## ADDENDUM TO THE CONTRACT

### JNU SREF Site Infrastructure

Contract No. E12-280

**ADDENDUM NO.:** ONE

GRADING PLAN

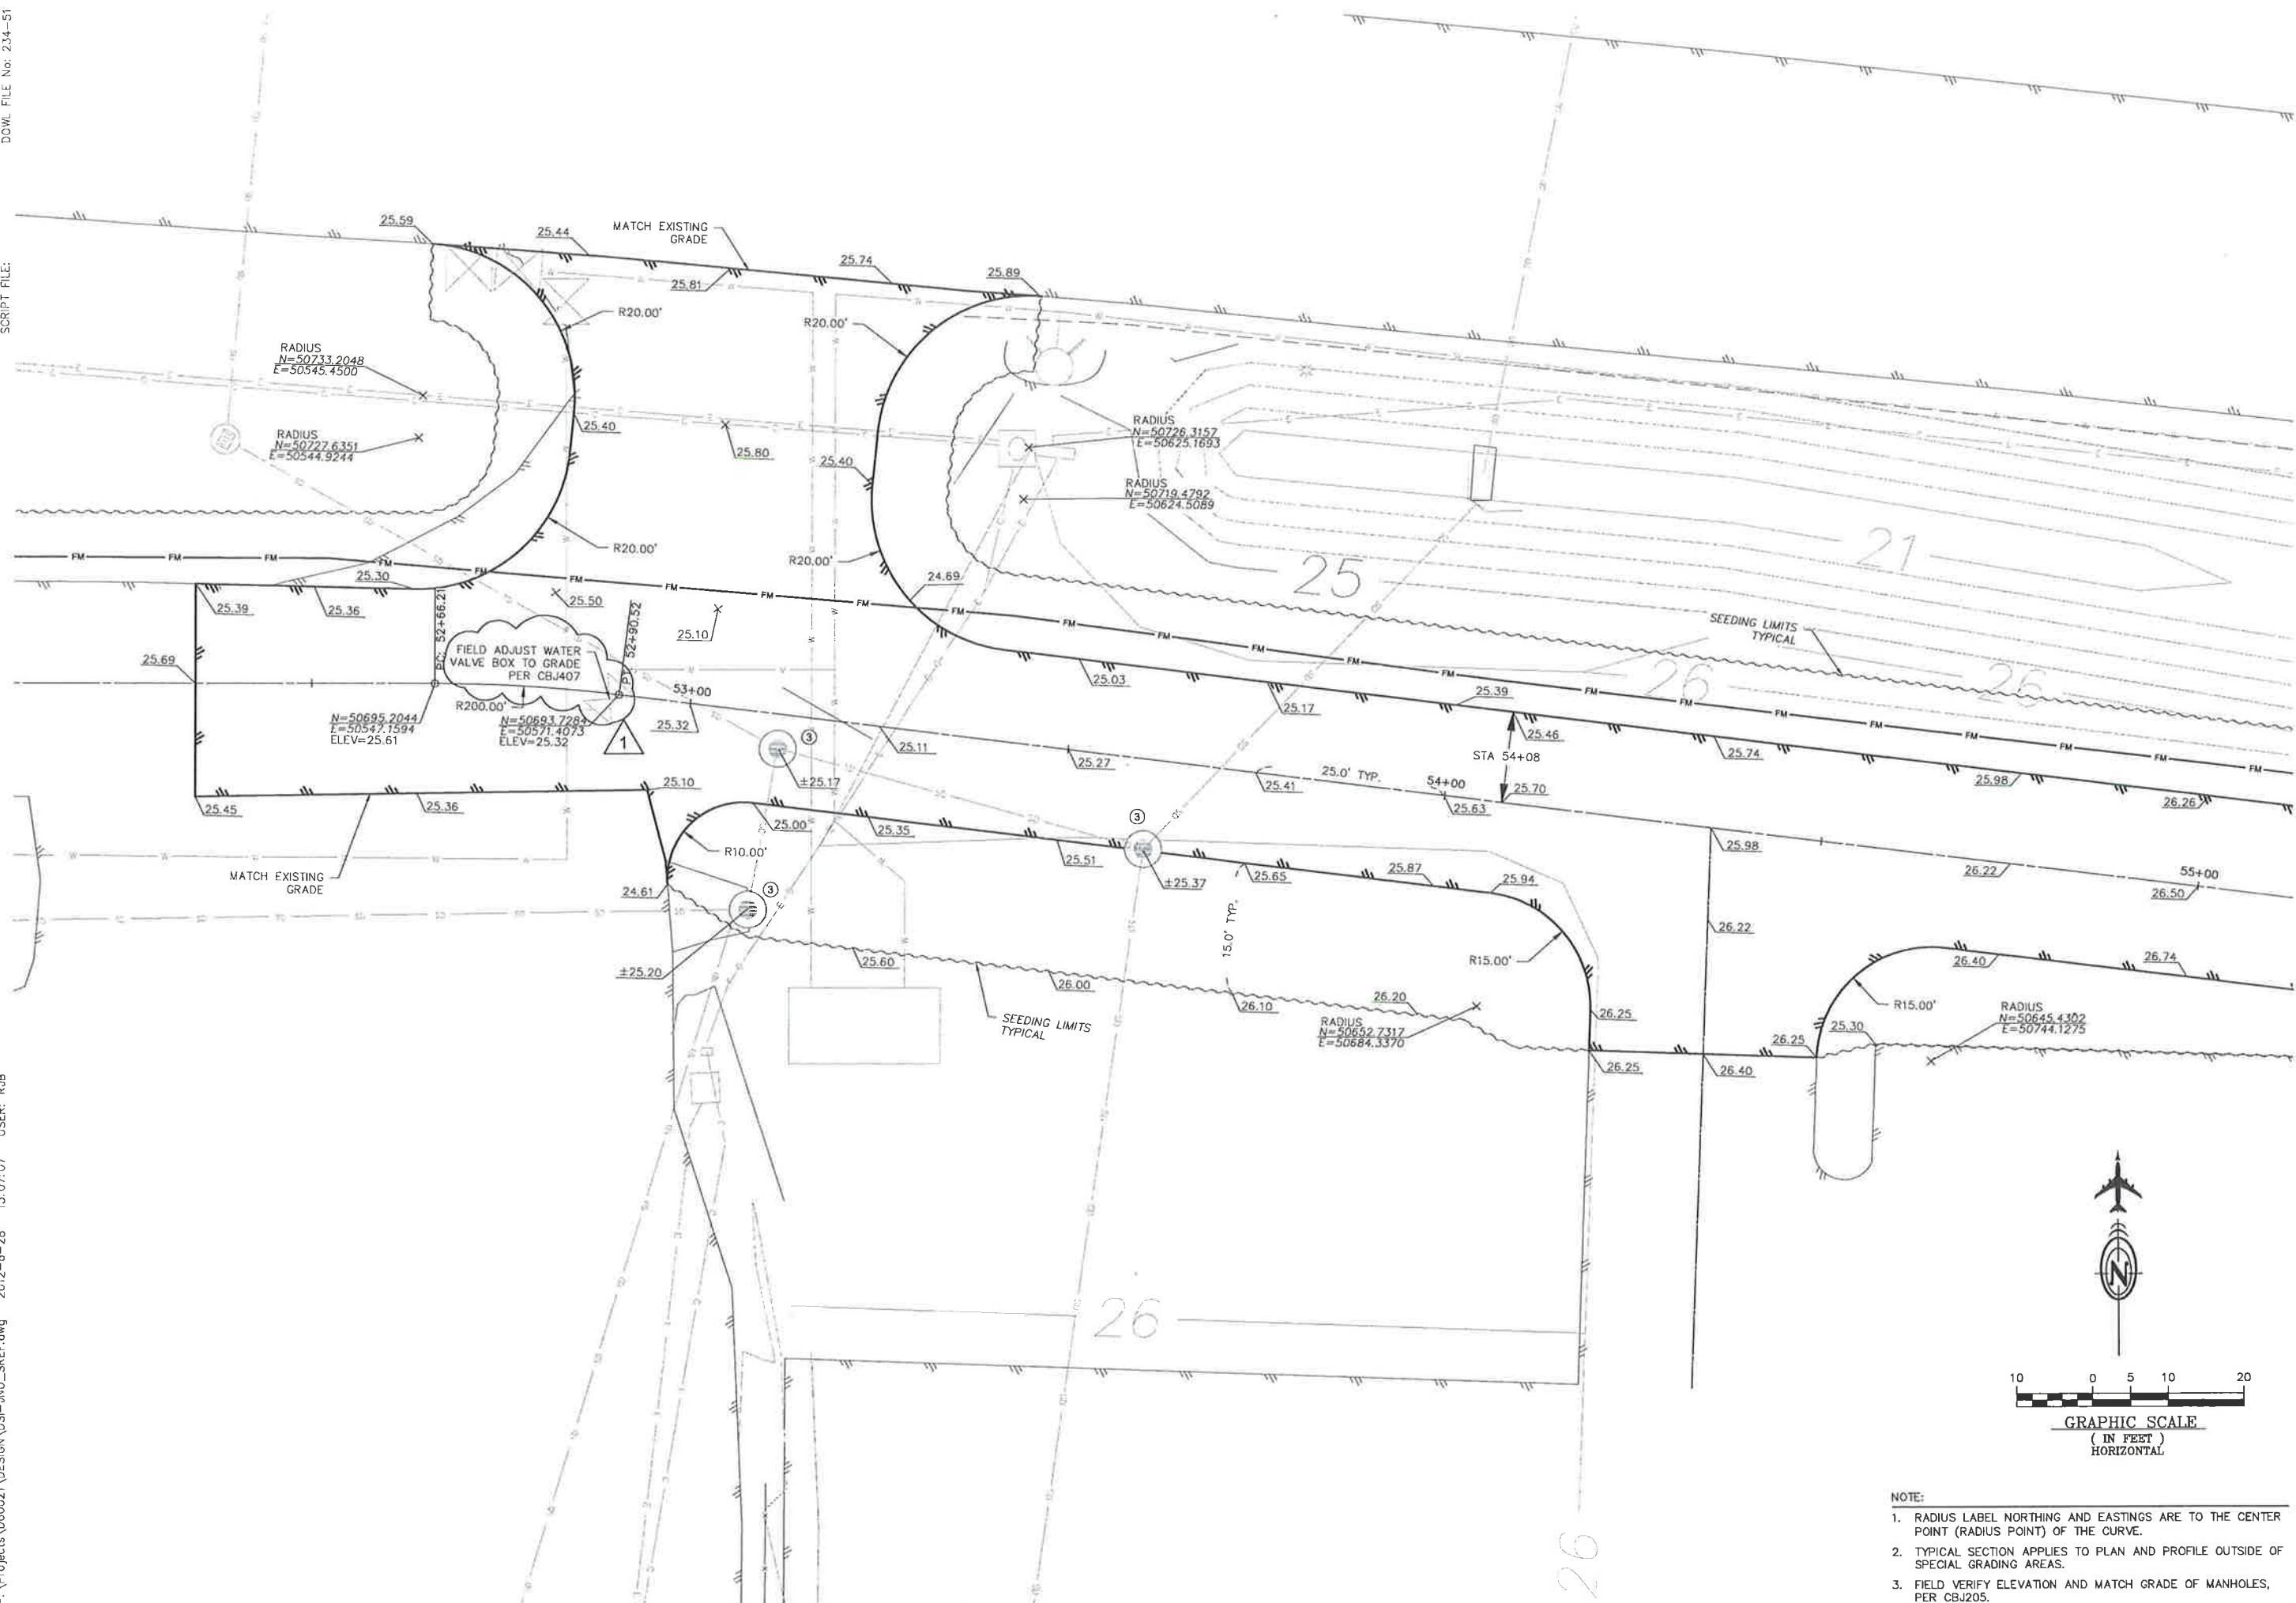
- Added note to Water Valve Box by Road station 52+90 "Field Adjust Valve Box to grade per CBJ 407"
- Added the following to Note 3: "Per CBJ 205"

- NOTE:
1. RADIUS LABEL NORTHING AND EASTINGS ARE TO THE CENTER POINT (RADIUS POINT) OF THE CURVE.
  2. TYPICAL SECTION APPLIES TO PLAN AND PROFILE OUTSIDE OF SPECIAL GRADING AREAS.
  3. FIELD VERIFY ELEVATION AND MATCH GRADE OF MANHOLES, PER CBJ205.

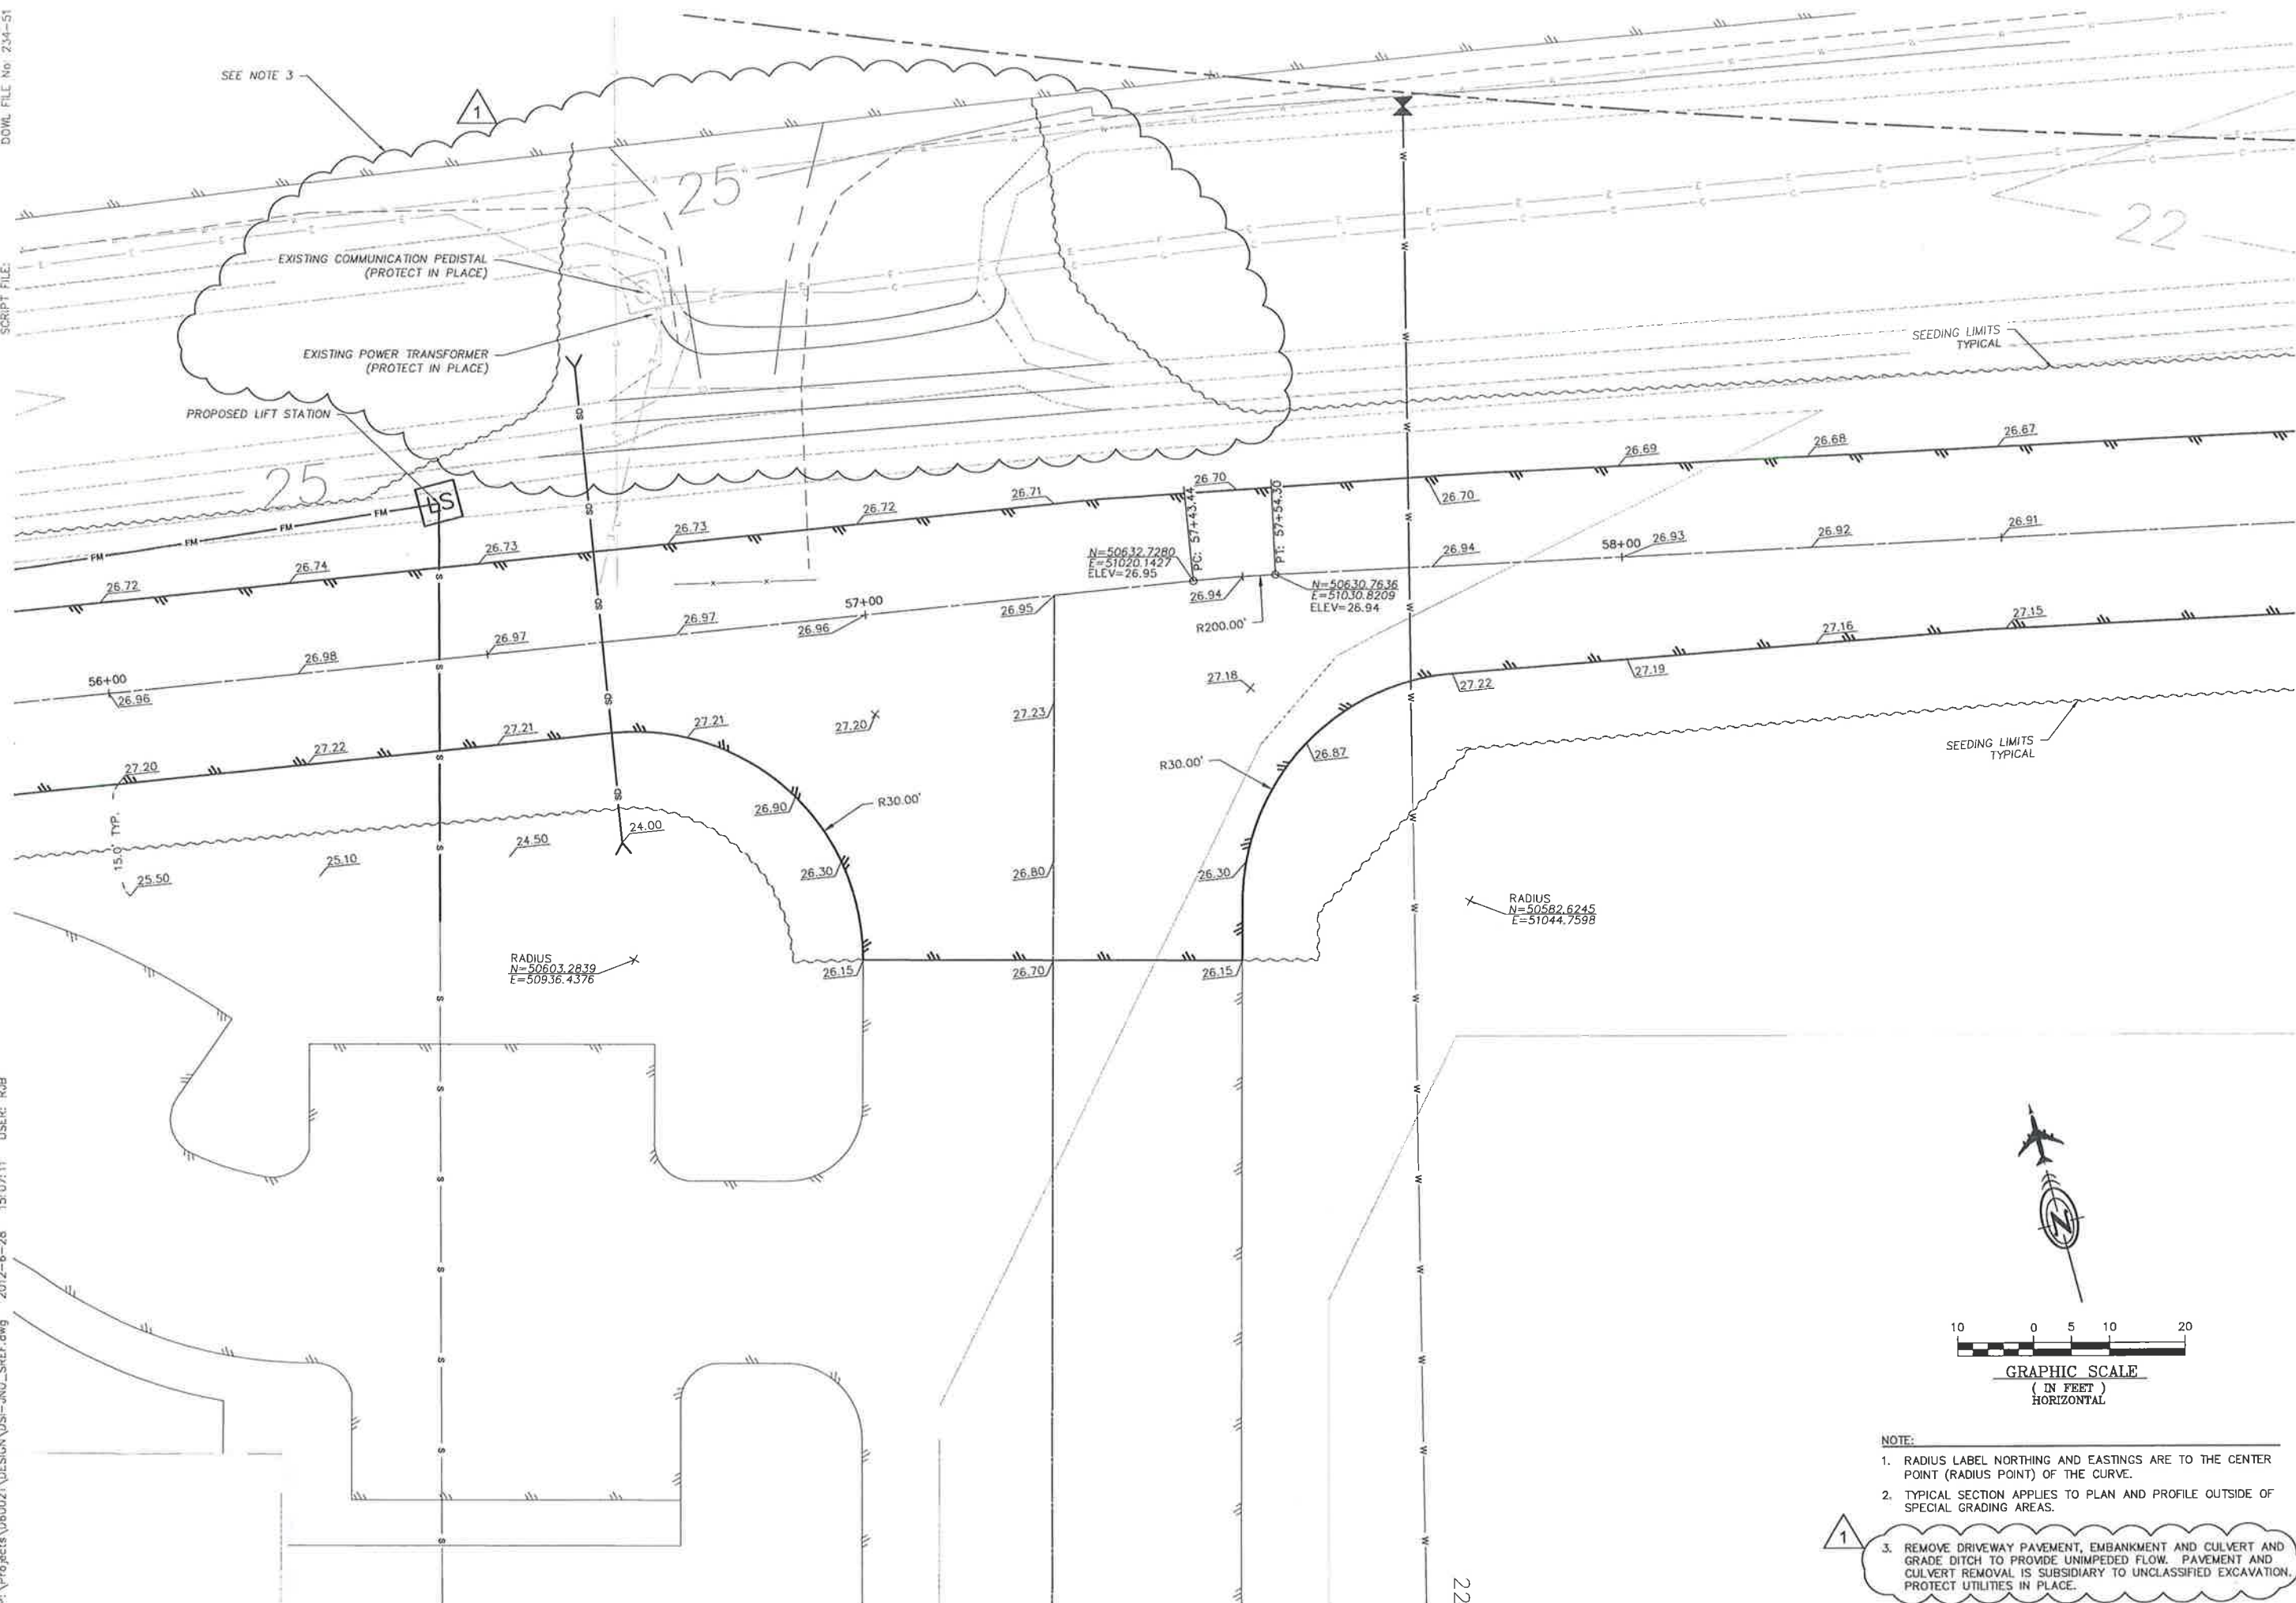
- Removal of existing Driveway, and culvert by station 57+00
- Expanded seeding limits

- NOTE:**
1. RADIUS LABEL NORTHING AND EASTINGS ARE TO THE CENTER POINT (RADIUS POINT) OF THE CURVE.
  2. TYPICAL SECTION APPLIES TO PLAN AND PROFILE OUTSIDE OF SPECIAL GRADING AREAS.
  3. REMOVE DRIVEWAY PAVEMENT, EMBANKMENT AND CULVERT AND GRADE DITCH TO PROVIDE UNIMPEDED FLOW. PAVEMENT AND CULVERT REMOVAL IS SUBSIDIARY TO UNCLASSIFIED EXCAVATION. PROTECT UTILITIES IN PLACE.

**SIGNING & STRIPING PLAN**  
 FILE NAME:  
 AUTHOR: TJA  
 REVISIONS:  
 06/28/2012

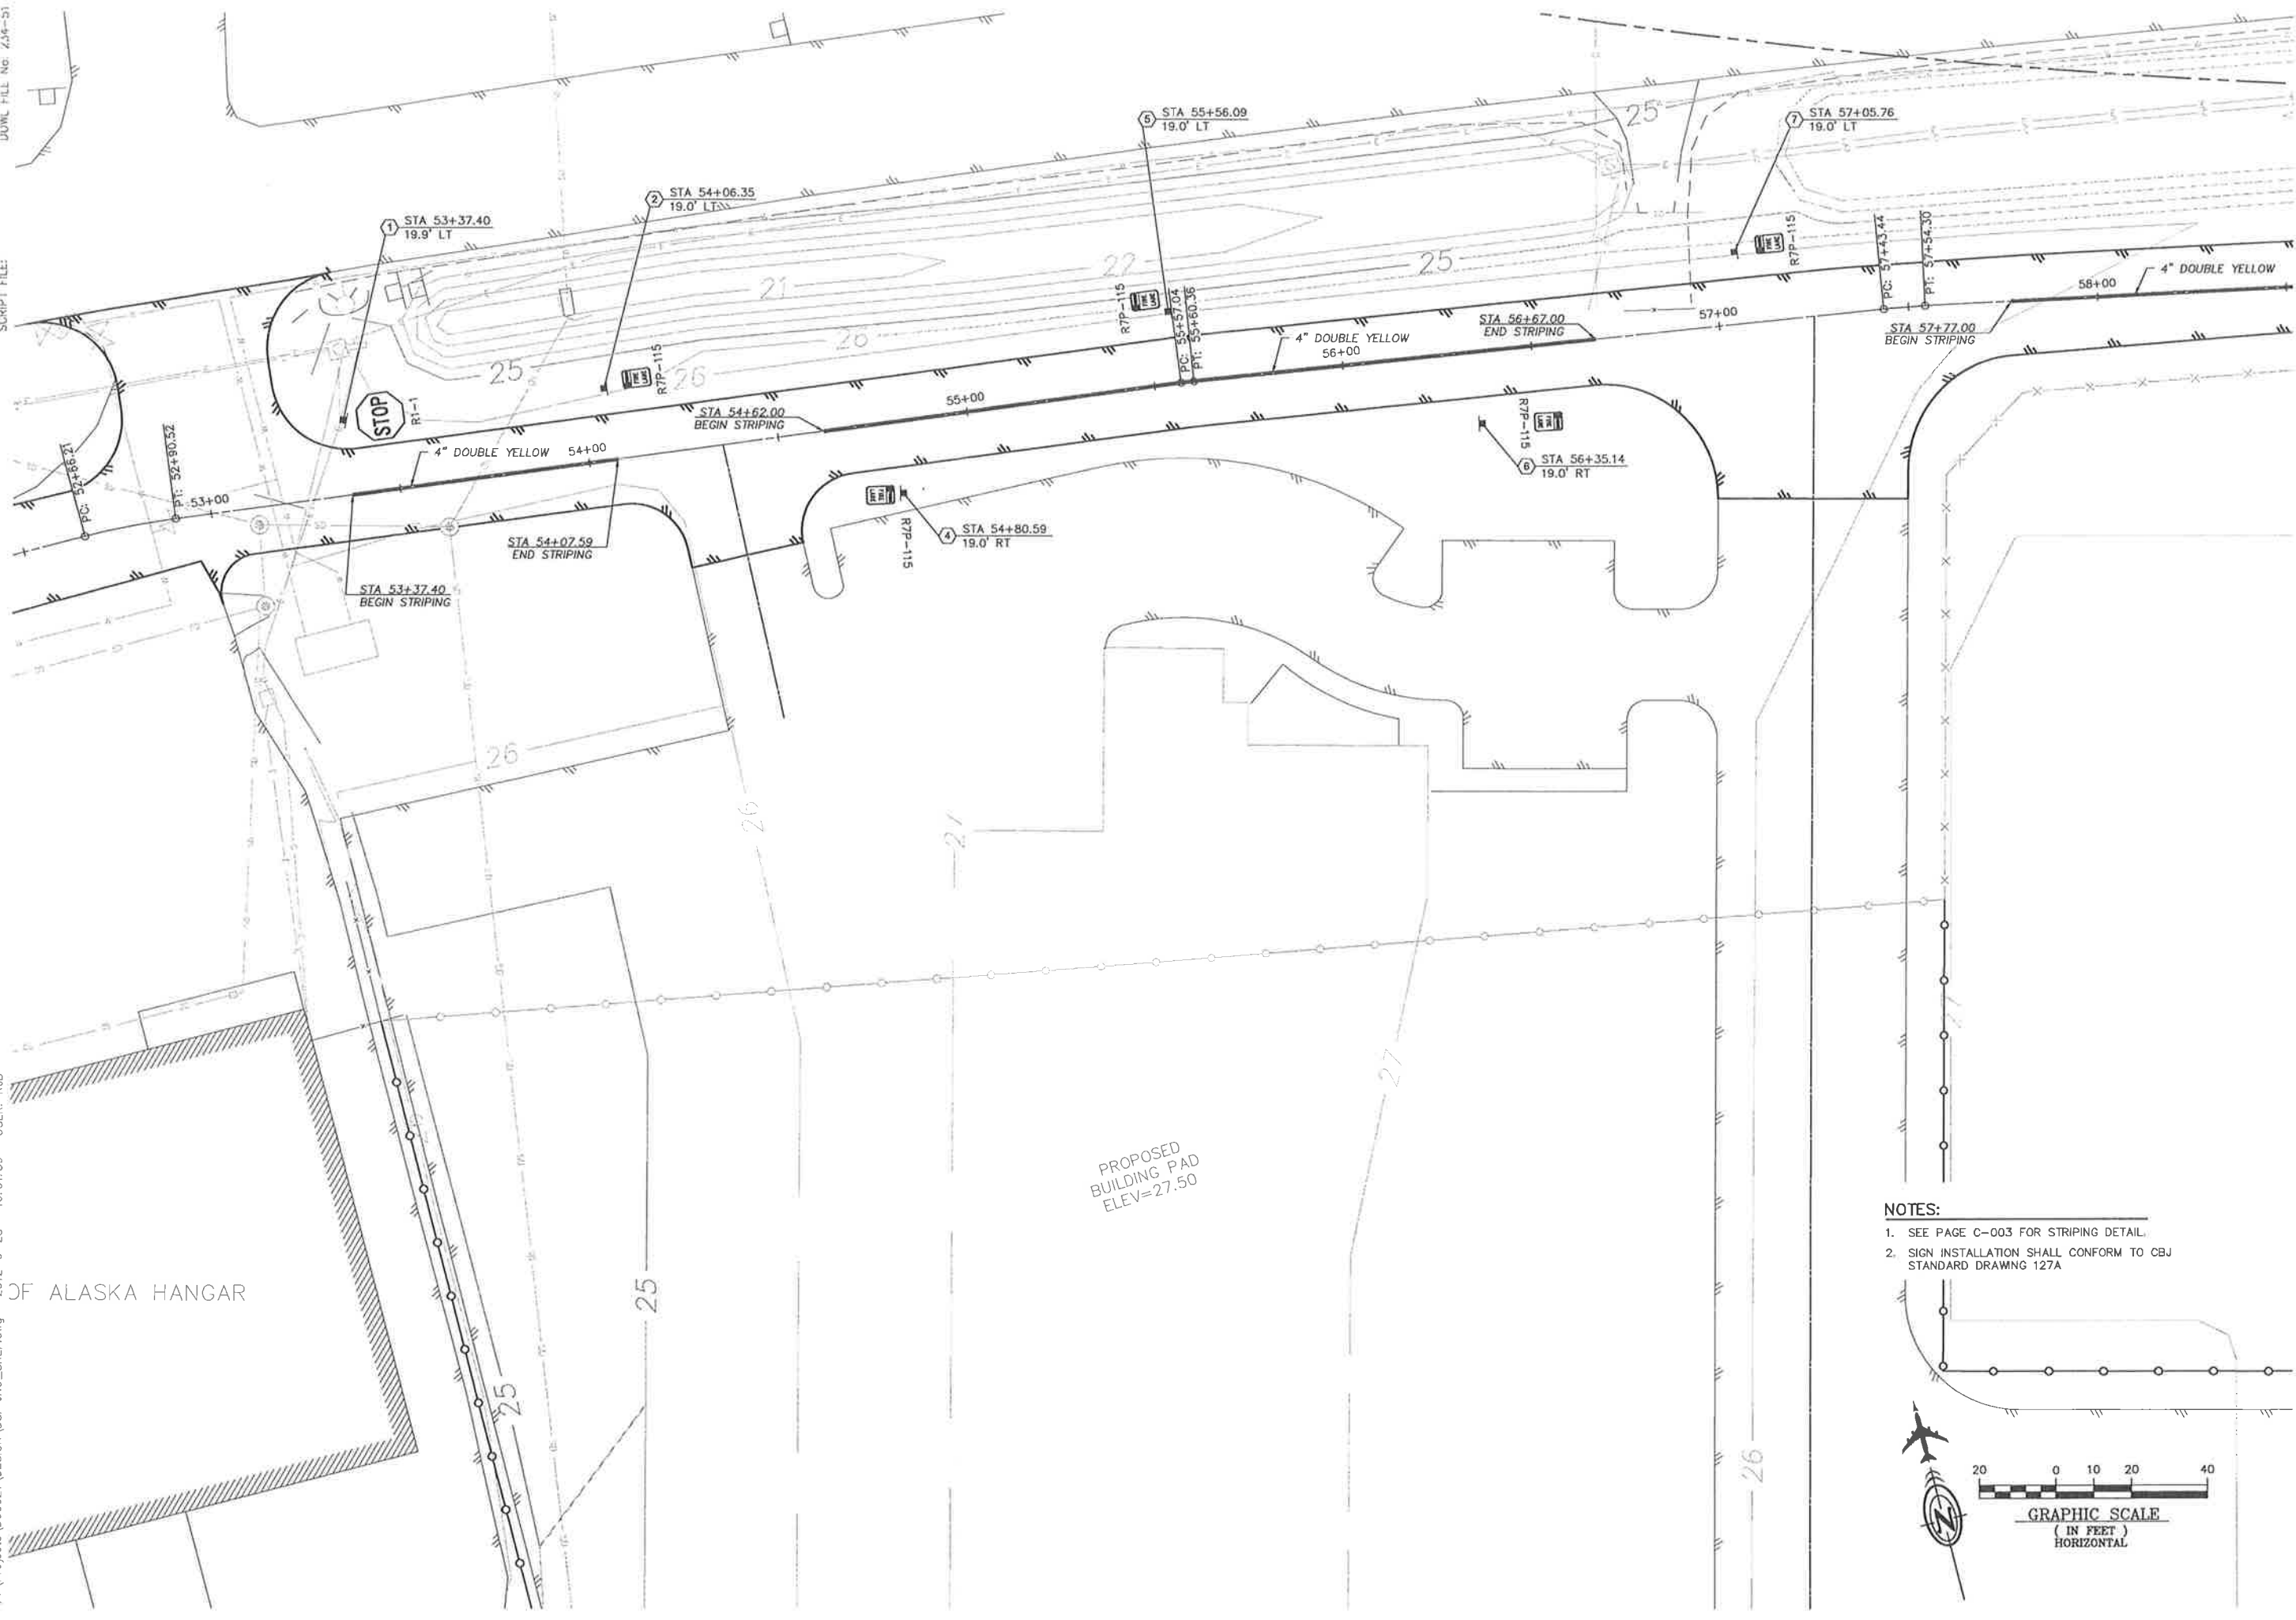
- Revised Proposed Building Pad Elevation from 27.00 to 27.50

PROPOSED BUILDING PAD  
ELEV=27.50
